HISTORIC AND DESIGN REVIEW COMMISSION

December 20, 2017

HDRC CASE NO: 2017-654
ADDRESS: 130 WICKES
LEGAL DESCRIPTION: NCB 931 BLK 1 LOT 29
ZONING: RM-4,H,HL
CITY COUNCIL DIST.: 1
DISTRICT: King William Historic District
LANDMARK: McDonald Rent House
APPLICANT: Manuel Vogt
OWNER: Manuel Vogt
TYPE OF WORK: Front yard landscaping, gutter and railing installation
REQUEST:

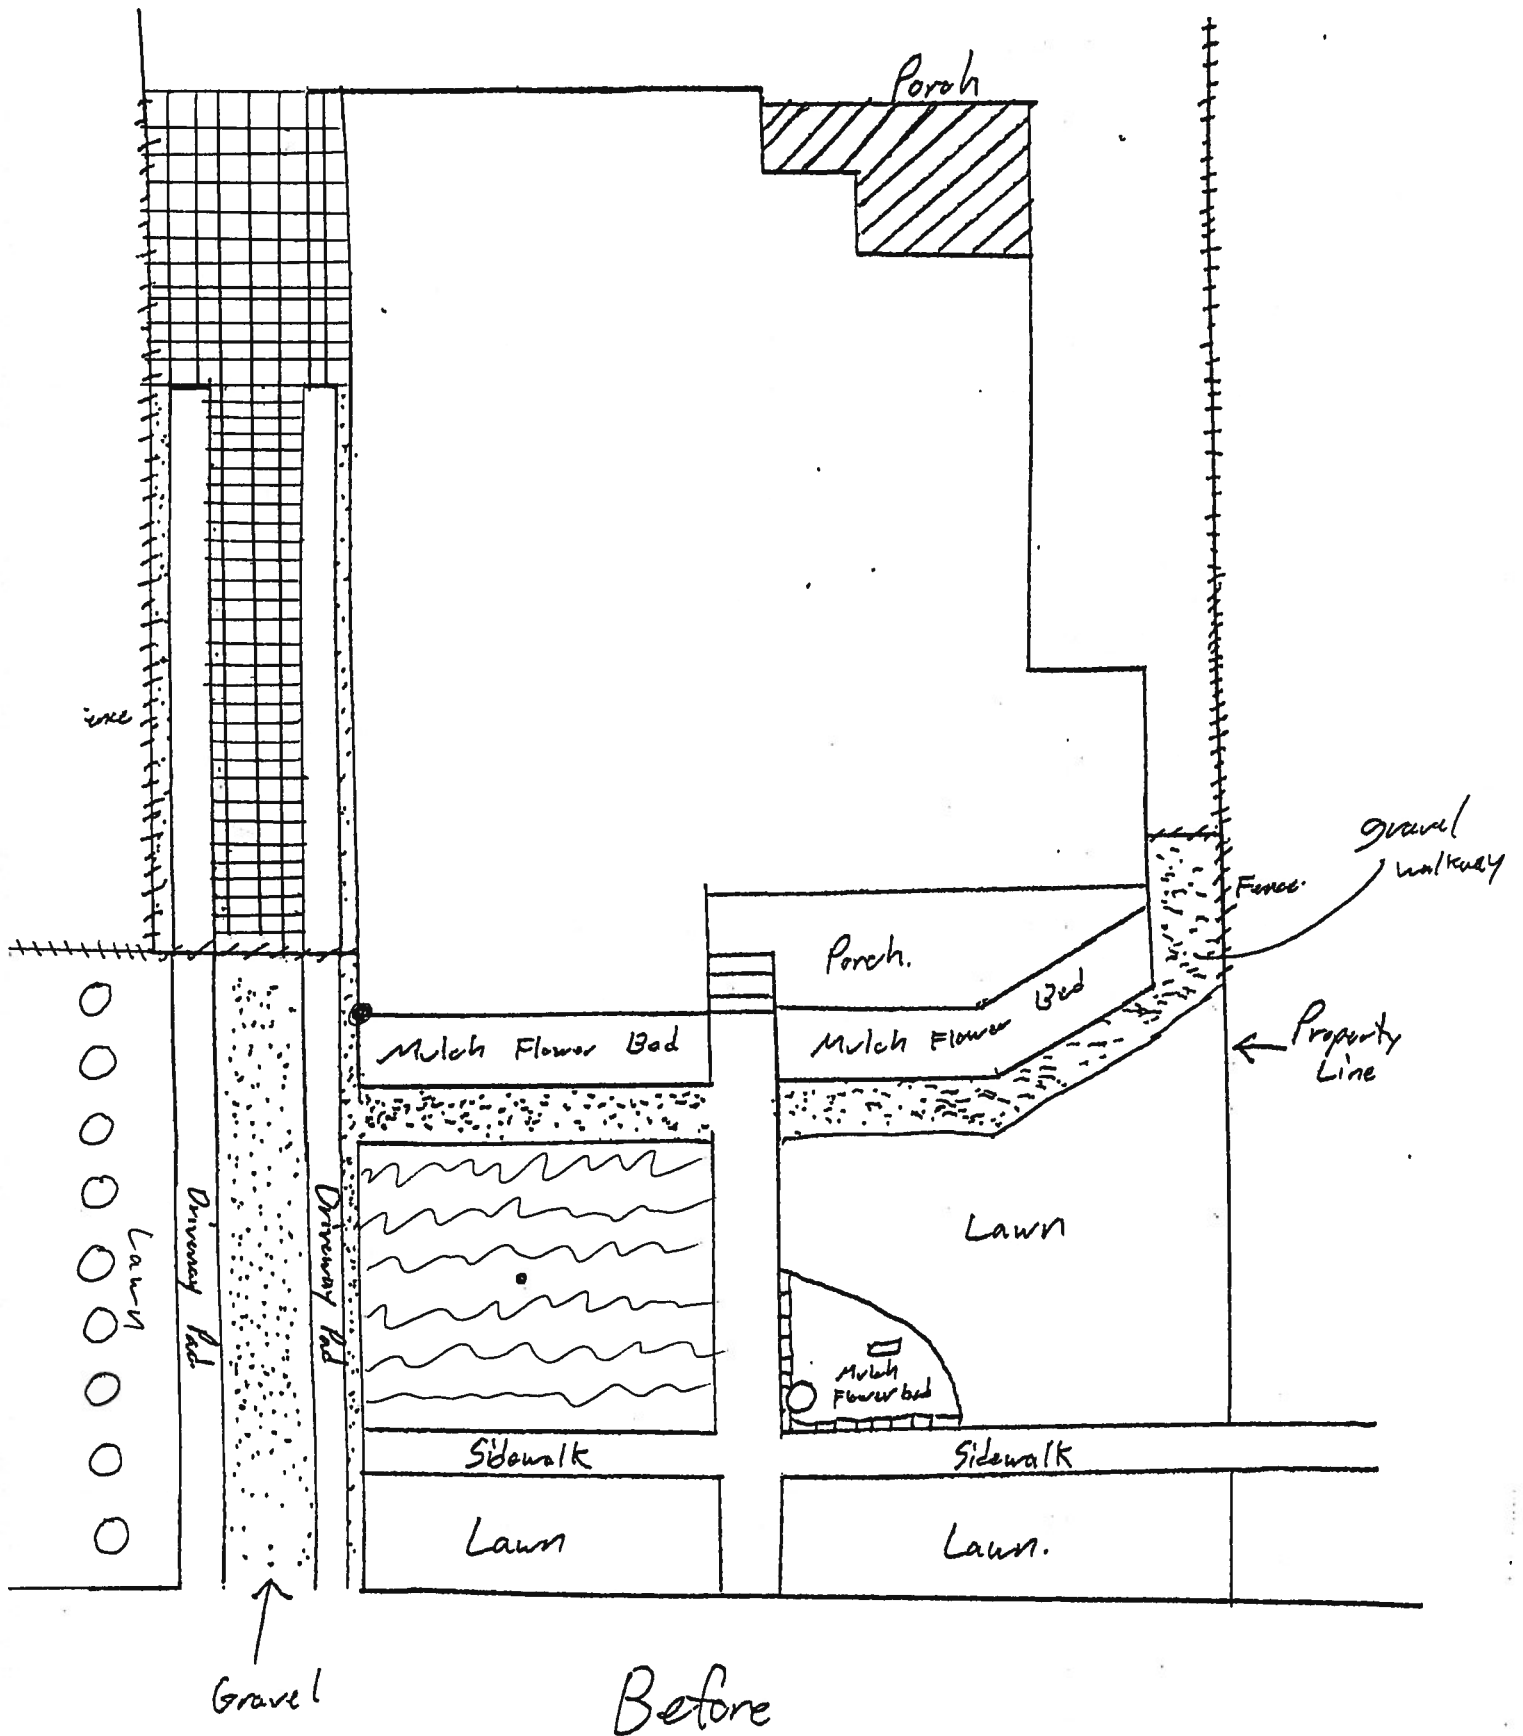
- d. RIVER ROCK – The applicant has proposed to remove the existing mulch from the planting beds adjacent to the foundation skirting and to install river rock. Staff find this installation appropriate given that it is limited to the area surrounding the foundation skirting.

- e. RIVER ROCK – The applicant has proposed remove the existing lawn area to the left of the driveway and install river rock and trees. Per the Guidelines for Site Elements 3.B.iii. rocks should not be a wholesale replacement for lawn area. Staff finds that a low growing, ground cover would be a more appropriate replacement.

- f. LAWN REMOVAL – The applicant has proposed to remove the existing, remaining lawn area and install a low growing plant material, a Carex species. Staff finds that this low growing plant will present itself similar to natural turf.

- i. That the applicant submit a final gutter detail to staff for review.
- ii. That the proposed front porch railings be wood and that a detail be submitted to staff for review.
- iii. That an evergreen ground cover be installed along the driveway instead of river rock.

After.

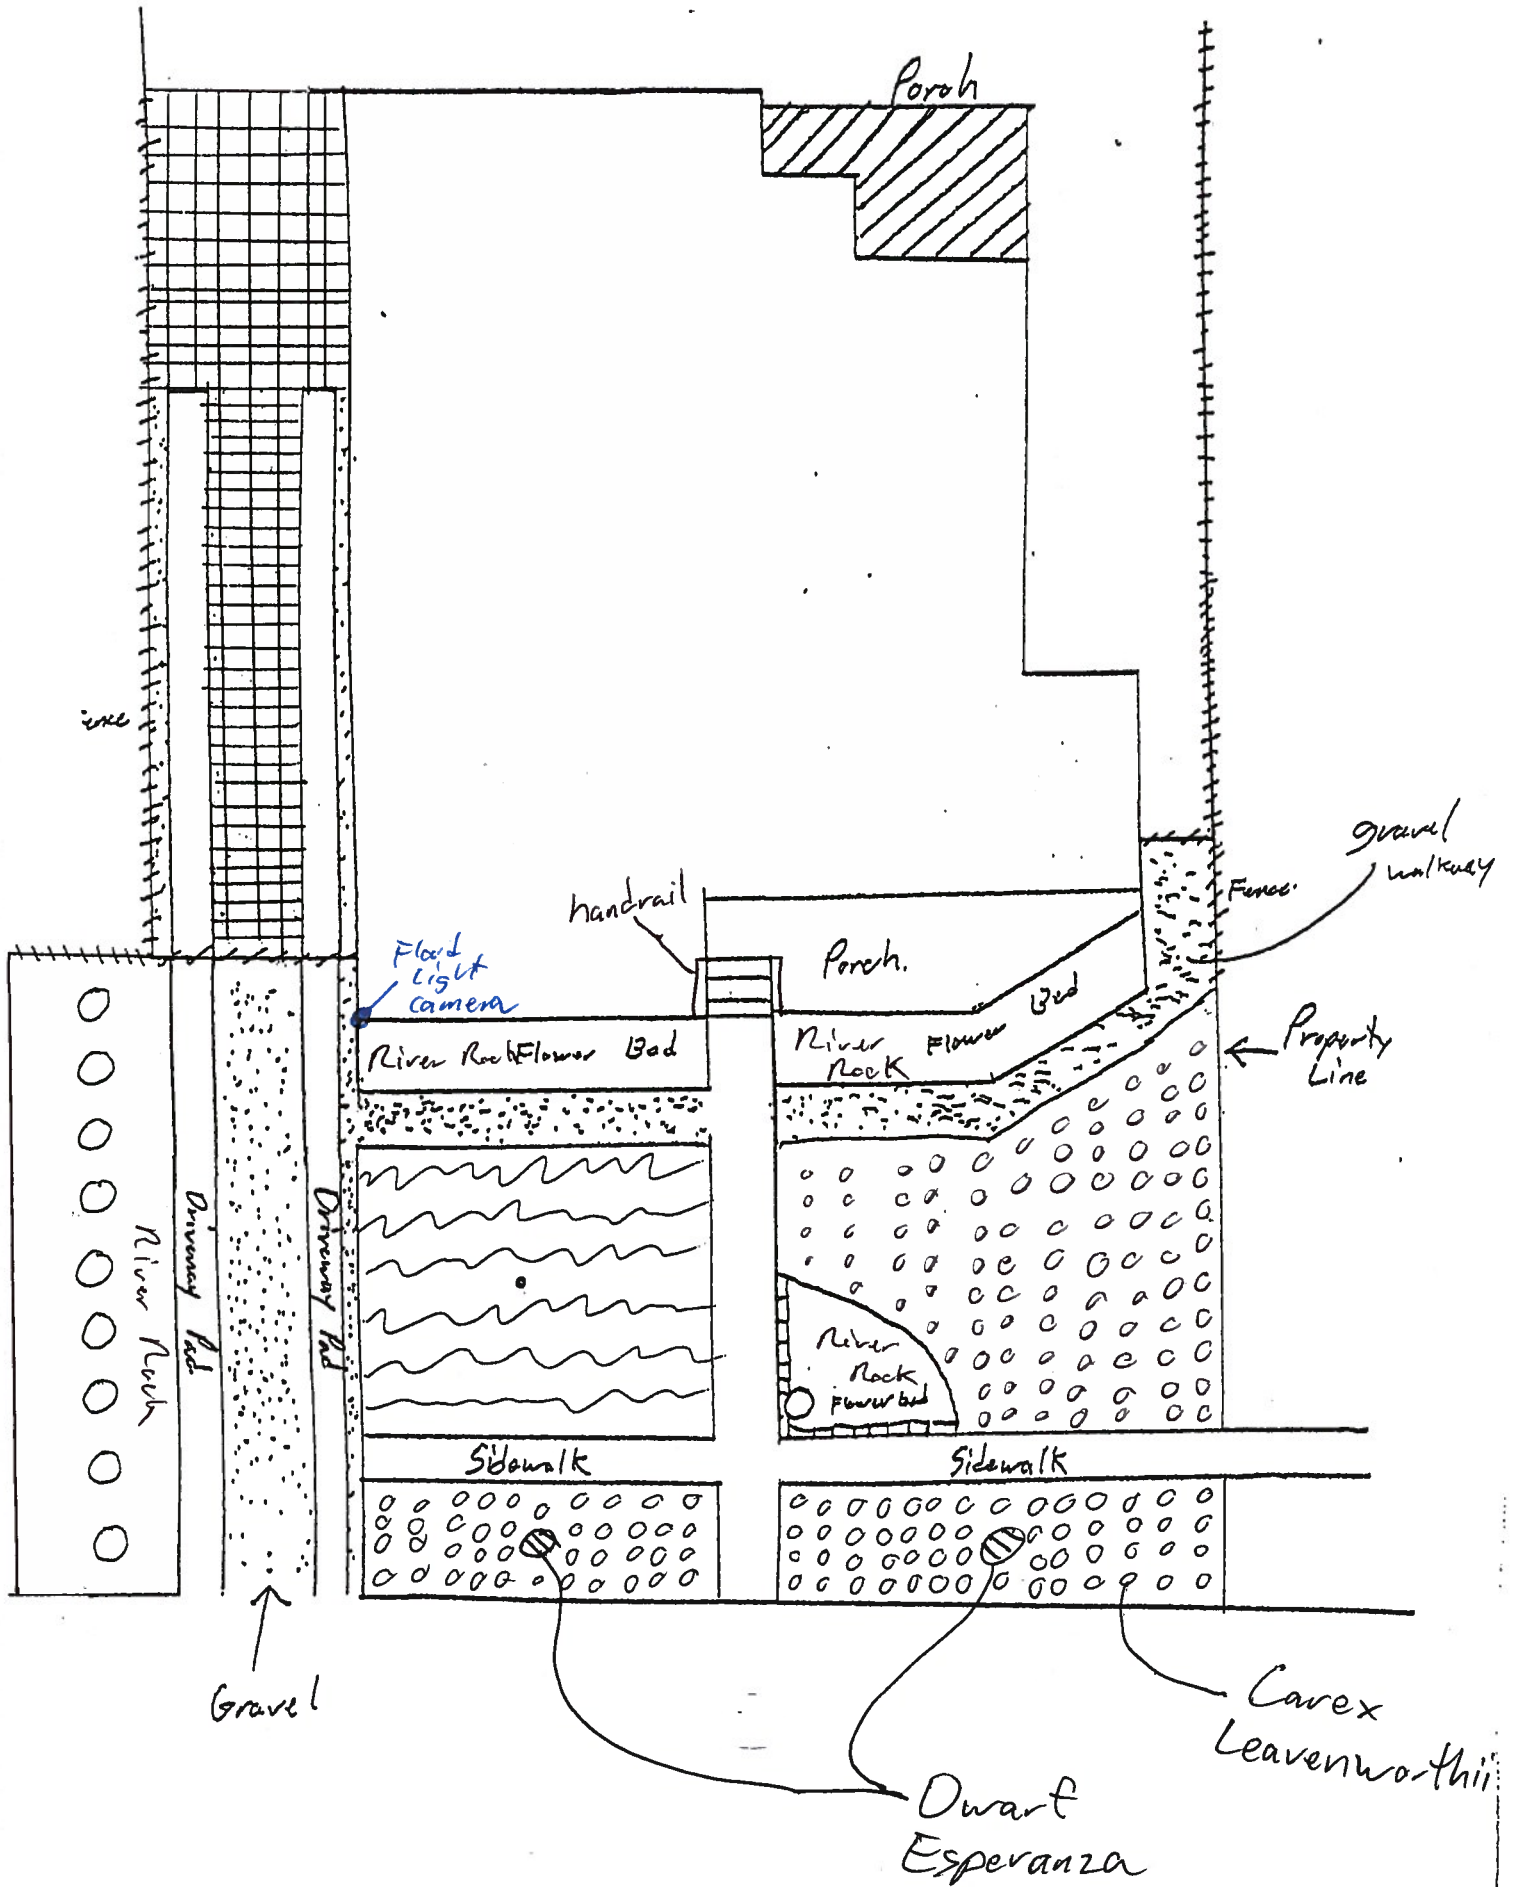
1. Mulch removal in following places and replace with river rock (see photograph)
 - a. Front Left Bed
 - b. Front Right Bed
 - c. Bed Surrounding Palm Tree

2. Grass Removal and replacement with river rock (see photograph) along left border of driveway (area surrounding baby gem boxwoods)
3. Removal of Grass at the following areas and replacement with Carex species (Leavenworthii, see photograph) as done at Monte Vista location which obtained historic approval (<http://www.gardenstylesanantonio.com/going-irrigation-free-in-monte-vista.html>). Consultation for our project received from Scott Ogden (see email) and work to be carried out by Rhinamic Workforce LLC (landscaping)

- a. Front Right yard next to palm tree (see photograph)
 - b. Front Right and Left grass pods in front of driveway (see photograph)
4. Installation of Dwarf Esperanza in two front pods (see photograph)
